UNION CARBIDE CORPORATION  
 MEDICAL PRODUCTS DIVISION  
 P.O. BOX 324, TUXEDO, NEW YORK 1987  
 TELEPHONE: 914-351-2131

August 20, 1981  
 8:11 AM 10 07

Reference: Union Carbide Corporation  
 Docket No. 70-687 License No. SNM-639

WASTE STORAGE FACILITY

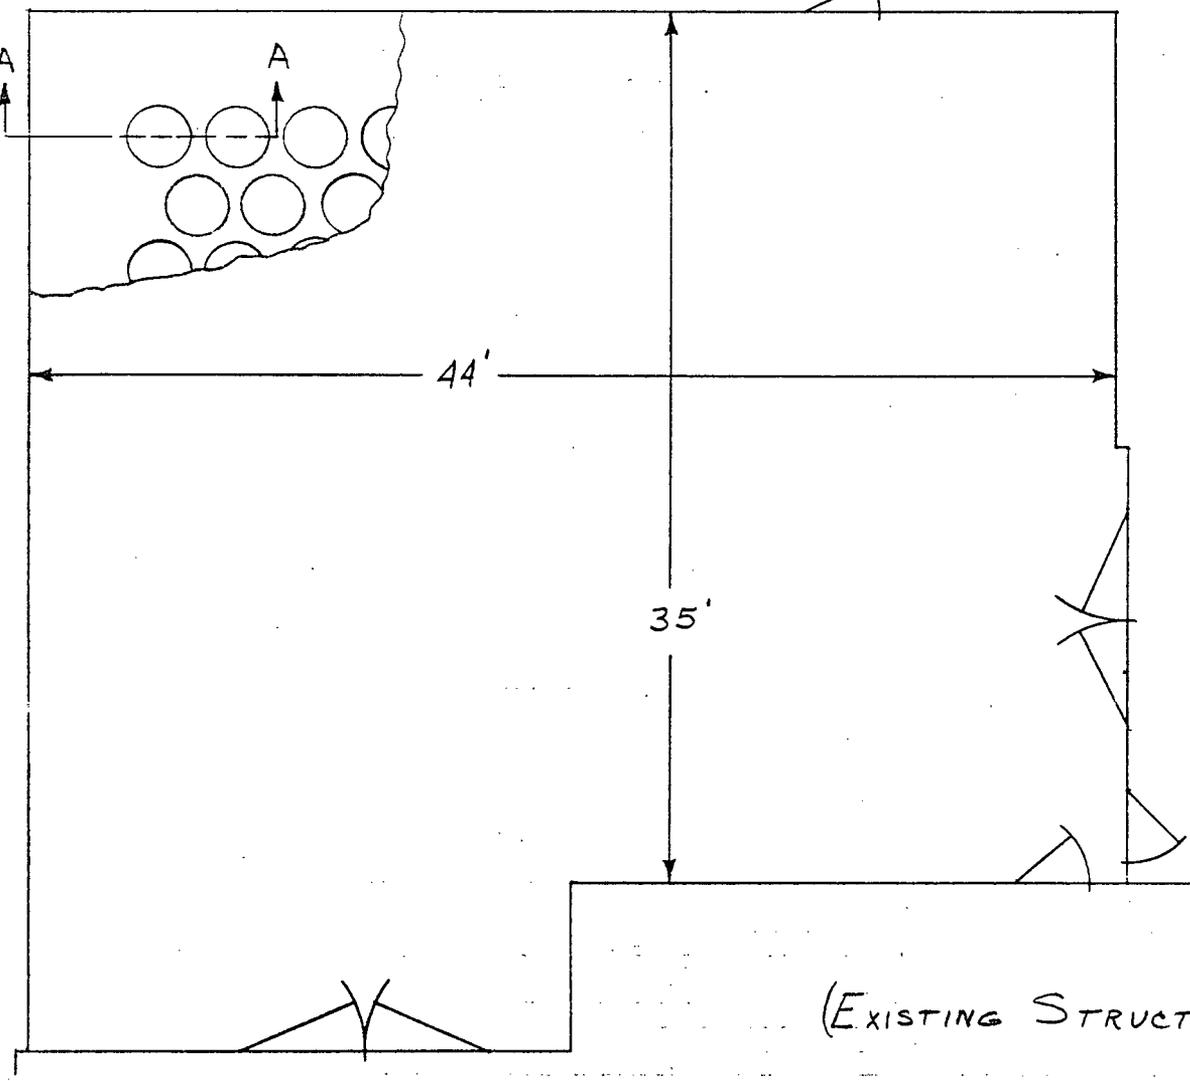
The waste storage facility modification, as shown in the attached drawing, is an addition to the existing structure of the same type of construction. The addition contains 100 individual storage compartments sized for 55 gallon waste drums in a honeycomb matrix. The storage cavities are 28" in diameter in a triangular array, with 10" of concrete separating any adjacent storage cavities at the closest proximity. The radioactive waste consists of bi-product material licensed by the state of New York under provisions of Agreement State Licensing in License No. 729-0322. Because of the level of radioactivity in the waste container, a minimum of 4' of concrete shielding is provided on all accessible surfaces of the storage facility. The waste to be stored in the facility is packaged to meet DOT and waste burial site requirements. Included in the waste may be up to 350 grams of U-235 per container. This is a known safe quantity for an individual unit in that it is less than one-half of the single parameter limit. In this specific geometry, the average density of U-235 over the storage array, assuming each compartment

contains its maximum quantity of material, is 0.569 grams per liter, which is substantially below the single parameter limit of 11.5 grams per liter multiplied by a factor of 0.5 to account for the moderating effect of the concrete lattice. Upon completion of the facility, which is scheduled for late September of this year, the protected area parameter will be expanded to include the addition to the facility. The effectiveness of the physical security plan will remain unchanged; a separate filing to the Commission will address this matter.

We specifically request that Condition 9 of our existing License #SNM-639 be amended, adding the date of this submittal. The specific amendment would thereby authorize the storage of up to 350 grams of U-235 in each of the 100 storage cavities of the waste storage facility described above.
